ORCHARD GARDENS REDEVELOPMENT

DEVELOPMENT FOR:  
FIRST COMMUNITY HOUSING  
245 W.WEDDELL DRIVE, SUNNYVALE, CA 94089

100%  
CONSTRUCTION  
DOCUMENTS &  
PERMIT SUBMITTAL  
ISSUED ON:  
07.14.2025

Misc. Plan  
Permit -  
Substantial  
Conformance  
Documentation

1 SITE PLAN - MISC. PLANNING PERMIT ADJUSTMENT DRAWING  
1" = 20'-0"

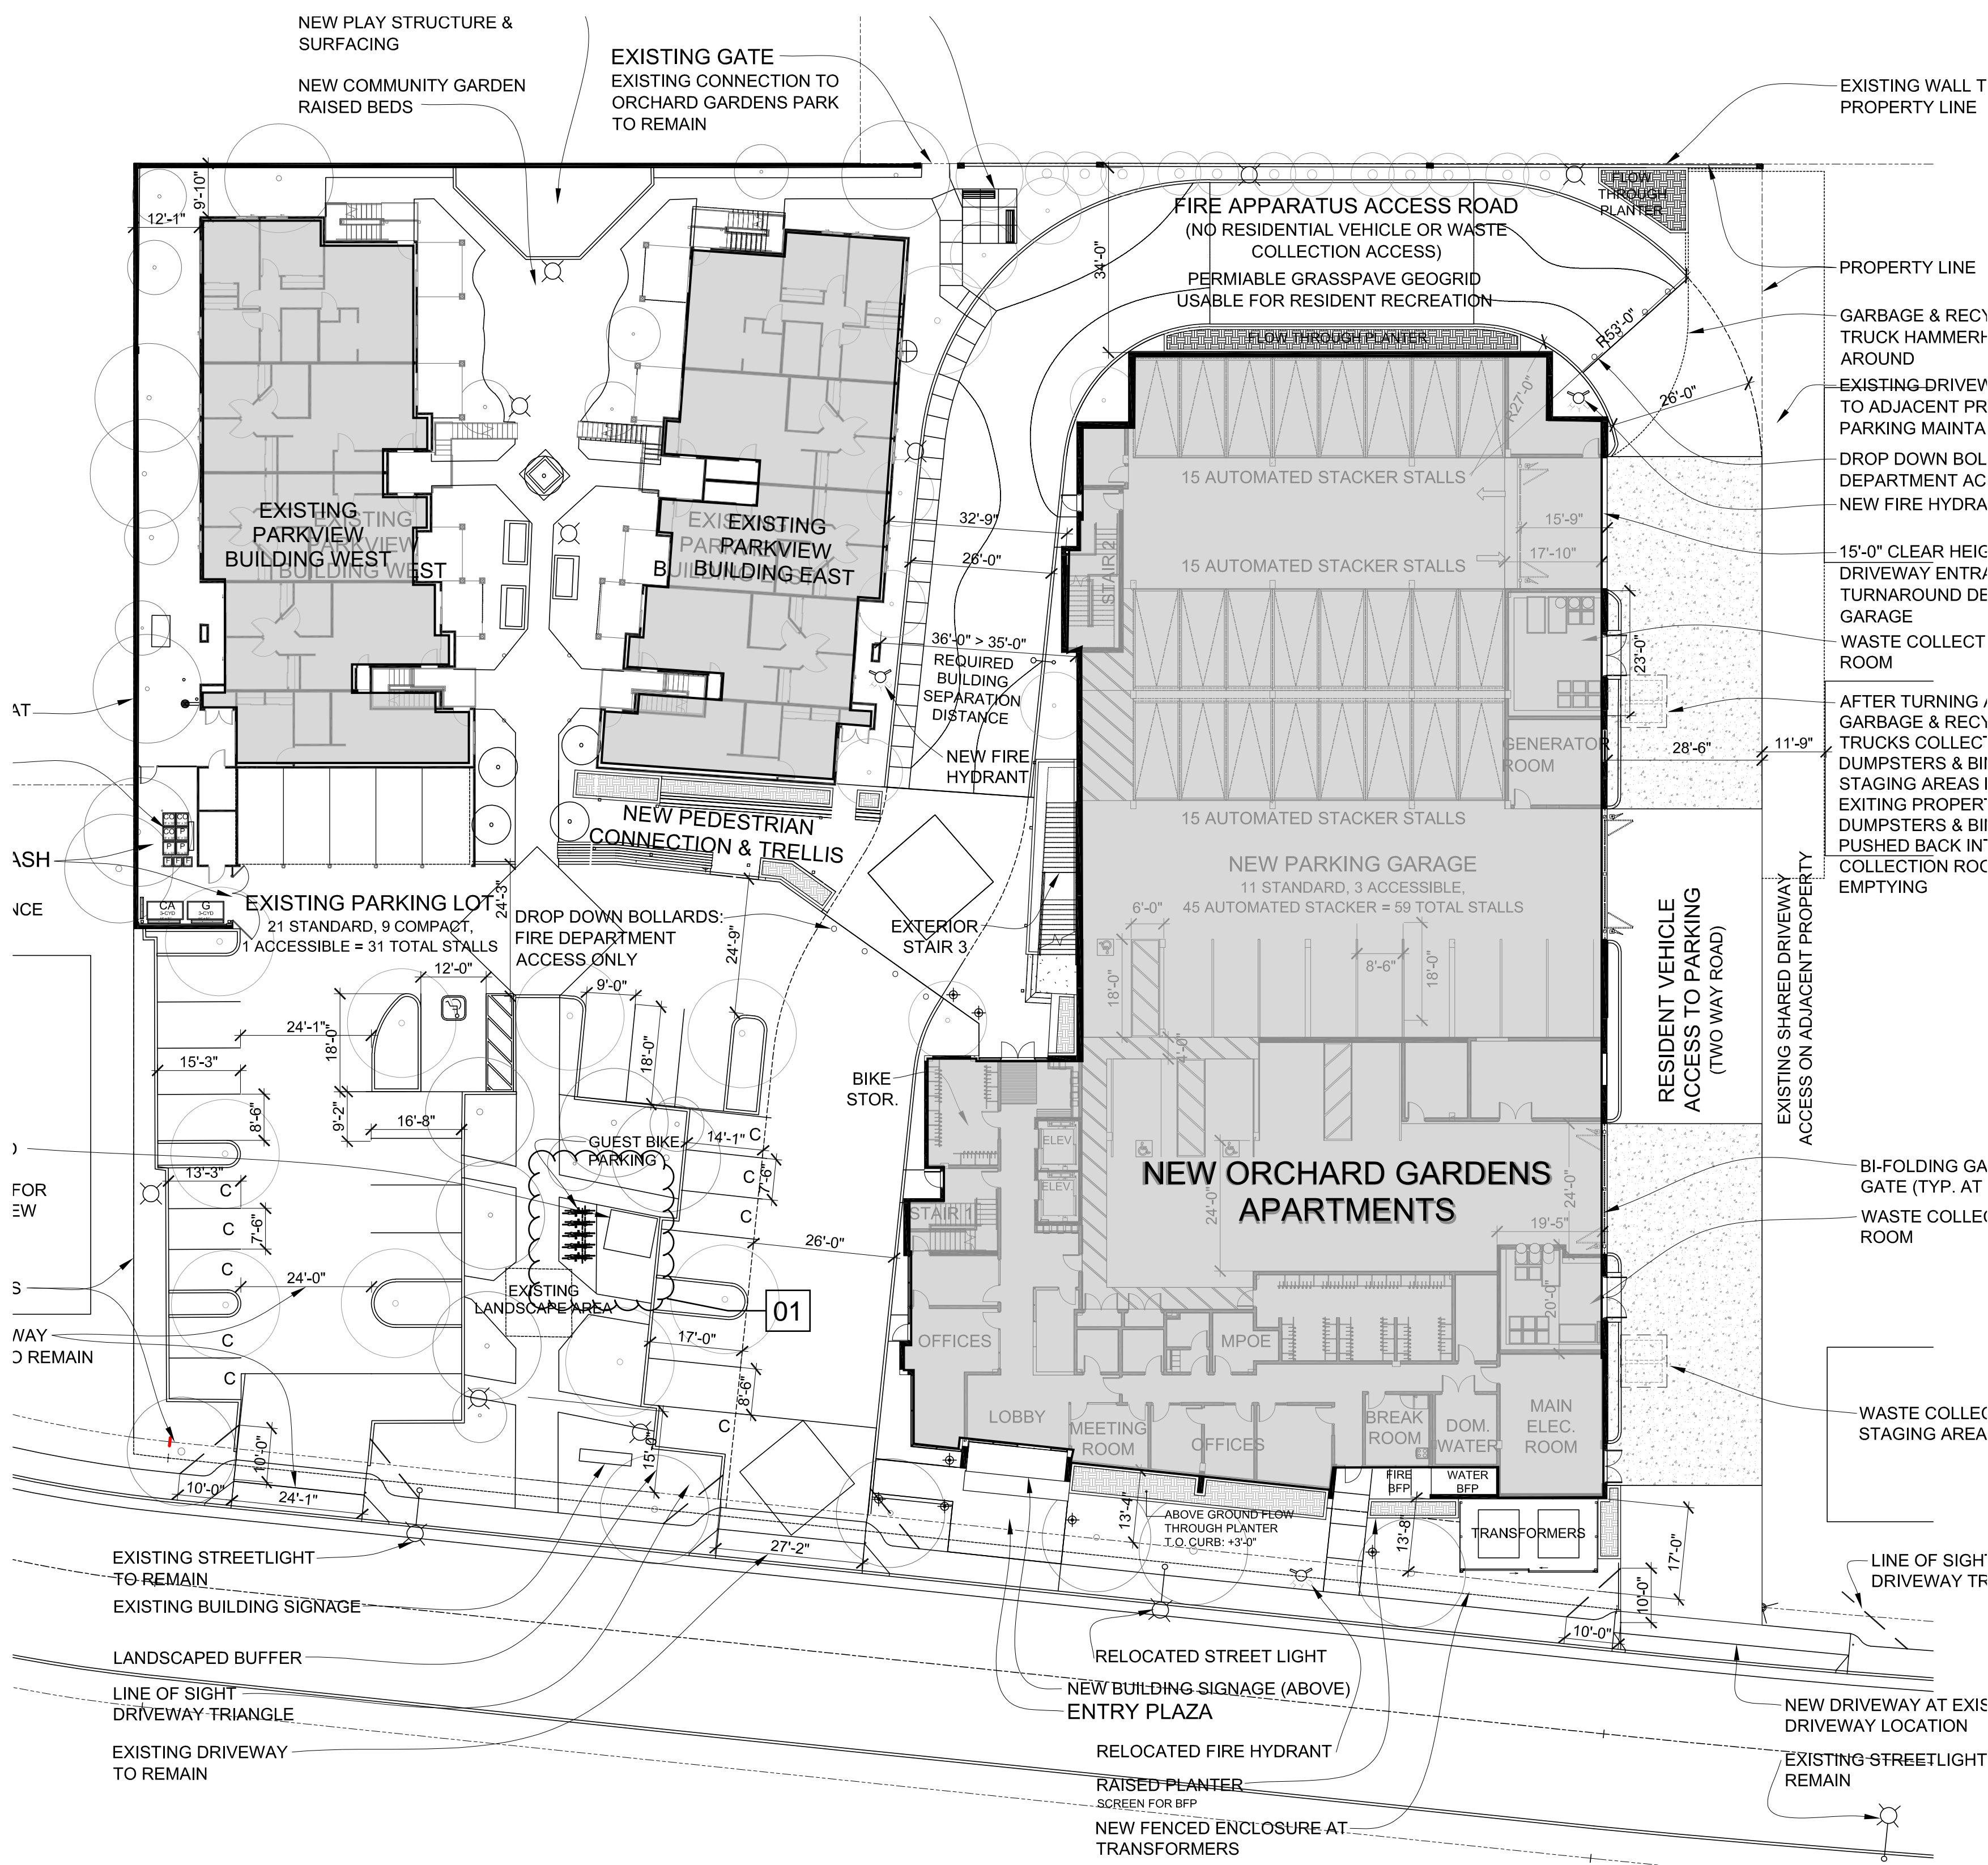
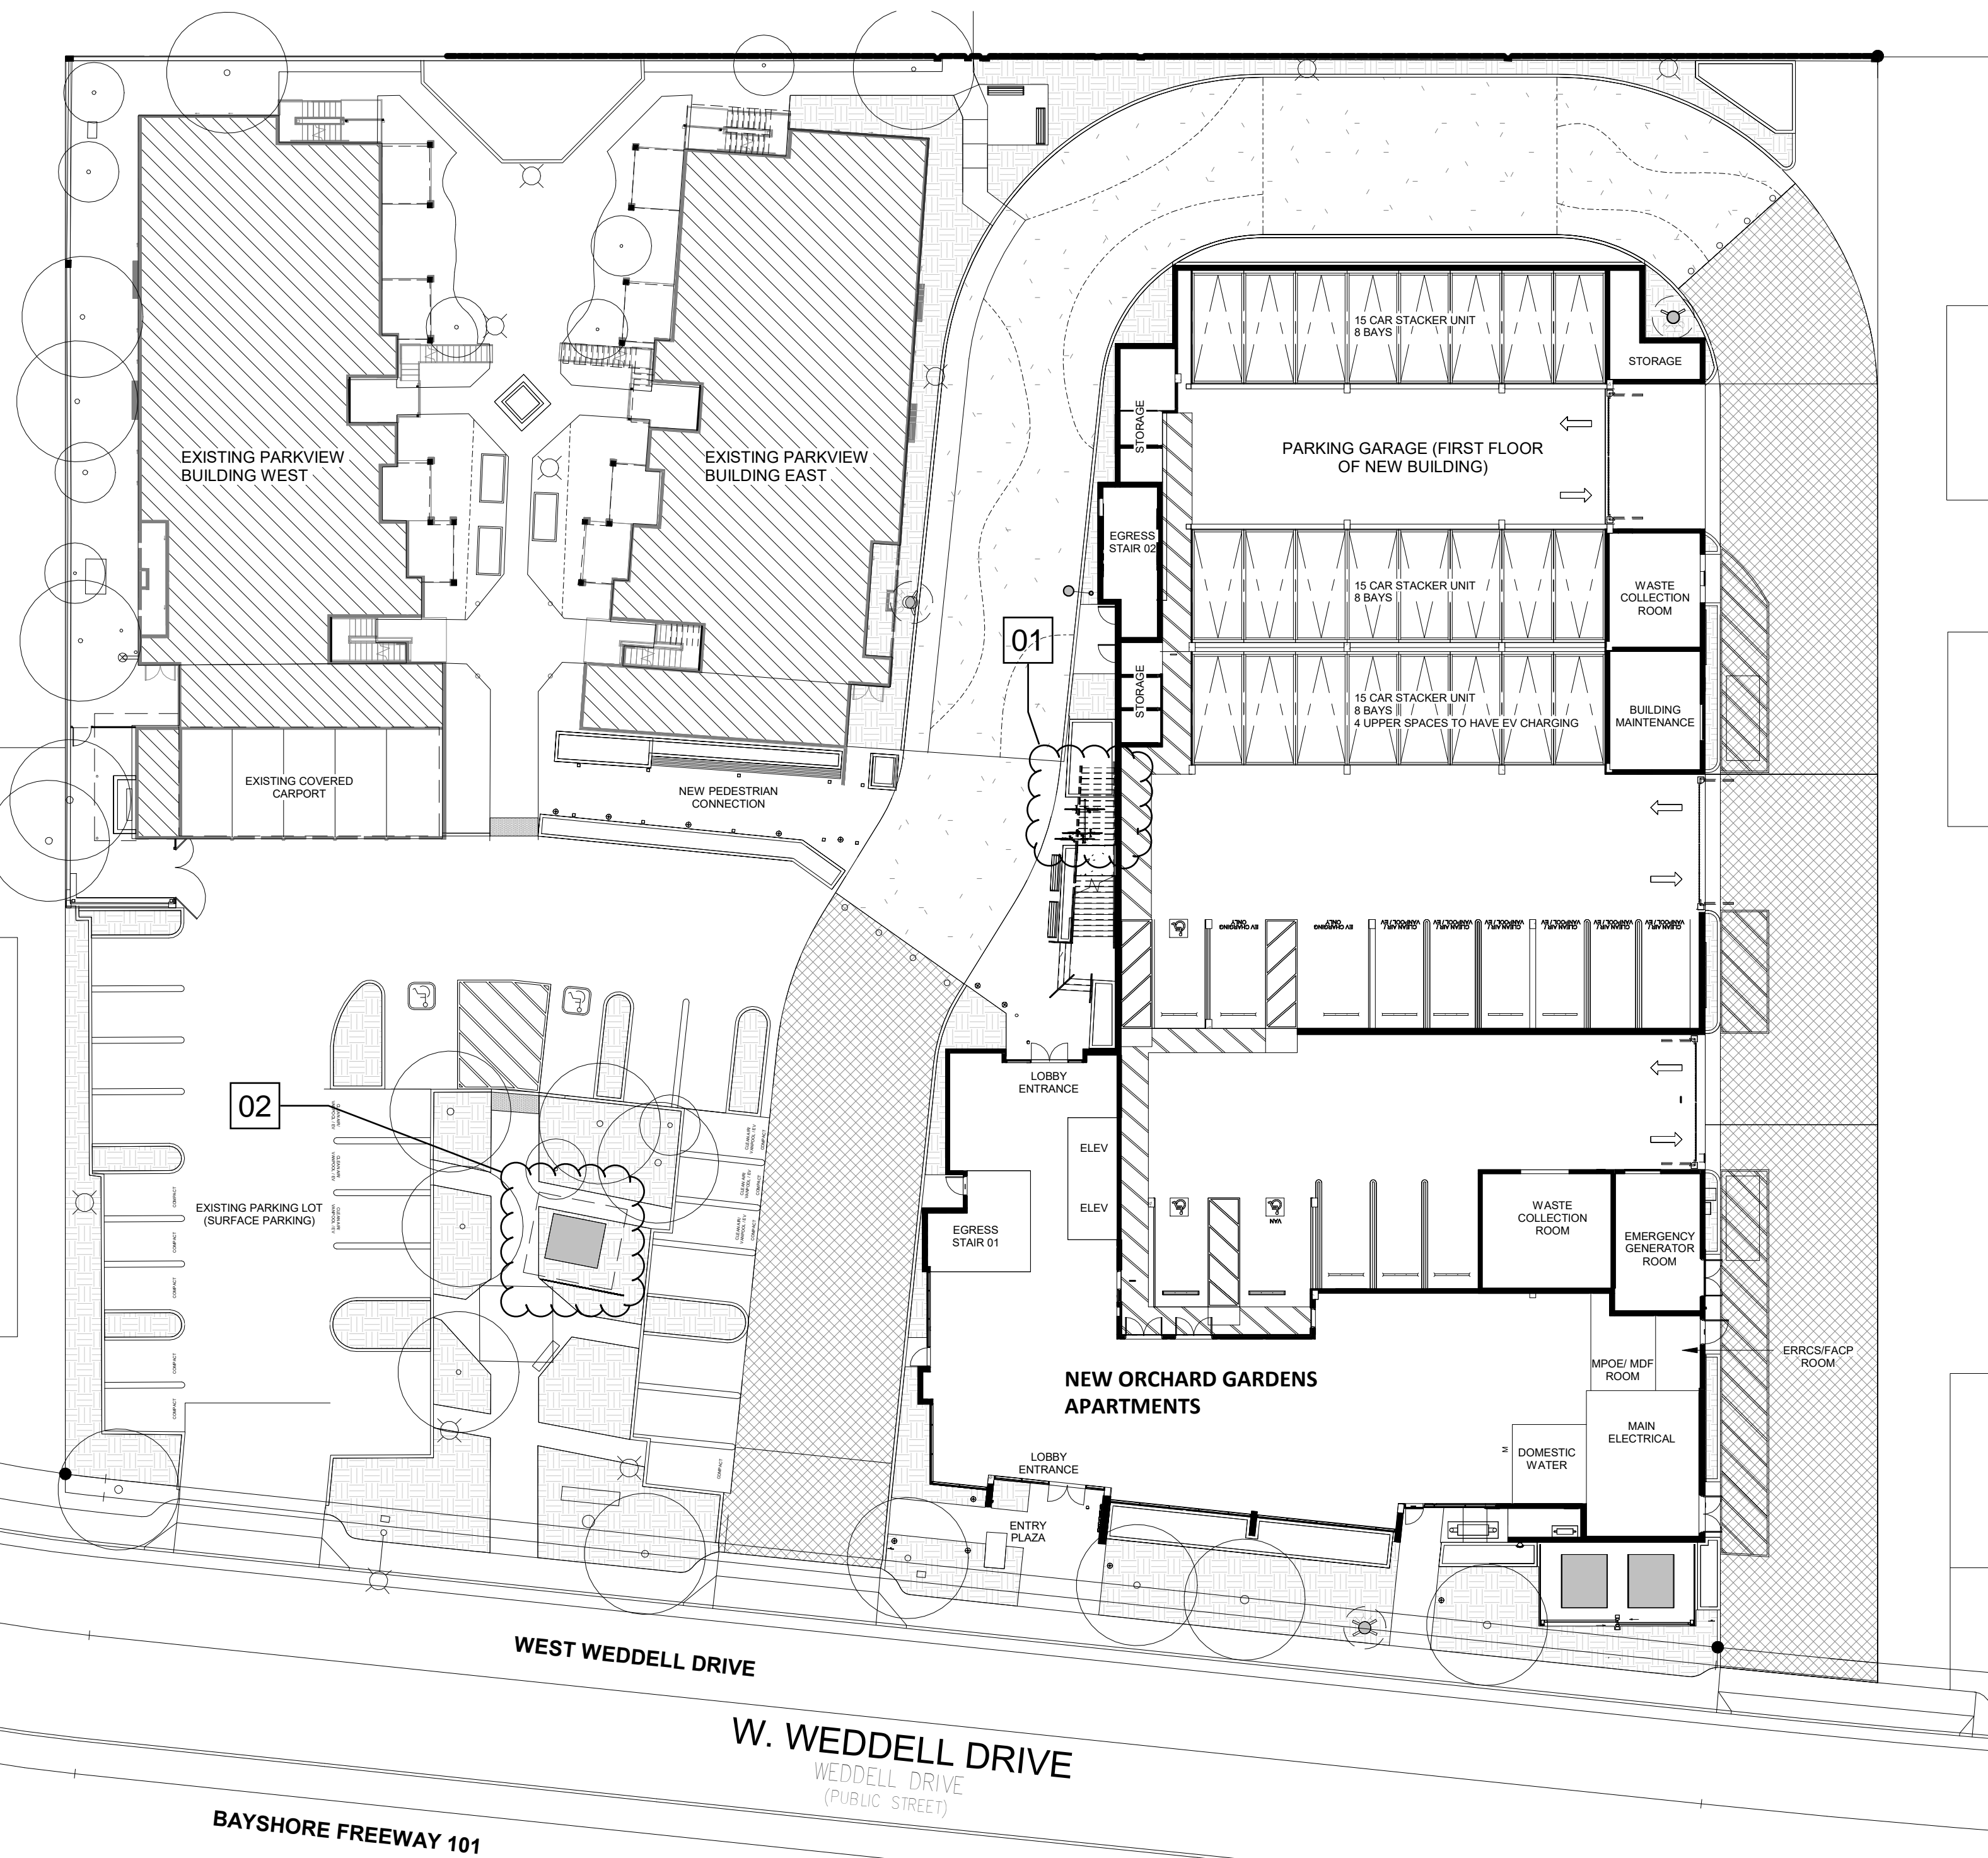
- 01 \*GUEST BIKE PARKING
- 02 \*SCREEN WALL AT PARKVIEW TRANSFORMER
- \*STARRED ITEMS WERE PART OF THE PREVIOUSLY REVIEWED MPP SET,  
REVIEWED AUGUST 2022

- 03 \*COMMUNITY ROOM RELOCATION AND COURTYARD ROTATION
- 04 \*EXTERIOR STAIR 04 REMOVED. ENLARGED RAISED PLANTERS IN PLACE.
- 05 \*BUILDING A COMMON ROOM AND RESIDENTIAL UNIT STACK SWAPPED
- 06 RELOCATED FLOW THROUGH PLANTERS
- 07 REMOVED LIVING ROOF OVER PODIUM ON SOUTHERN FRONTAGE
- 08 REMOVED ALL BALCONIES.
- \*STARRED ITEMS WERE PART OF THE PREVIOUSLY REVIEWED MPP SET,  
REVIEWED AUGUST 2022
